Technical Bulletin

Models All Maytag built Side by Side Dispenser & Non Dispenser Models
1998 to Current.

Issue Hollow Ice and Clumping and Jamming of Ice.

No: TDR-0009-B
Page 1 of 4

Figure 1

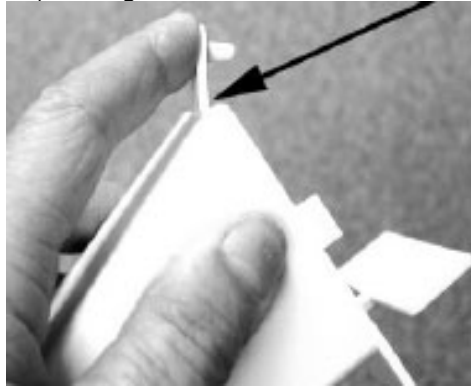
- Using your finger remove the icemaker air tunnel coil cover-locating tab (this is only used on current production models) See figure 1.

Figure 2

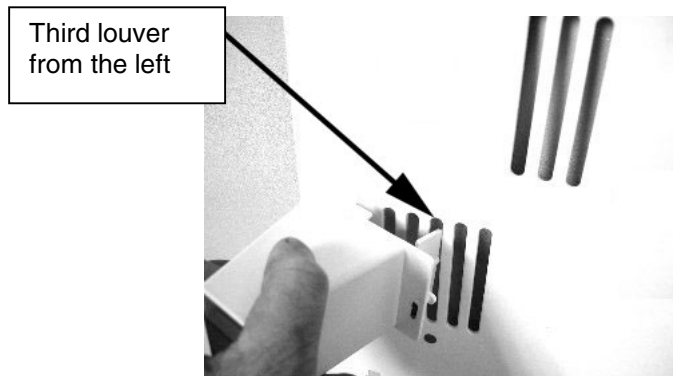
- Turn the icemaker air tunnel 90°. Insert the air diverter into the upper evaporator coil cover louvers, second row third slot in from the left. (See figure 2).

Figure 3

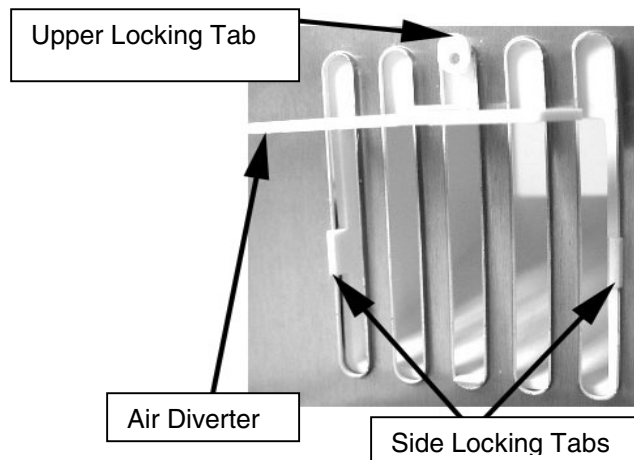
- Rotate the air tunnel counter clockwise 90°. Make sure the side and the upper locking tabs are locked in place behind the coil cover. (See figure 3)

Note: Figure 3 is for reference only - you do not have to remove the evaporator coil cover.
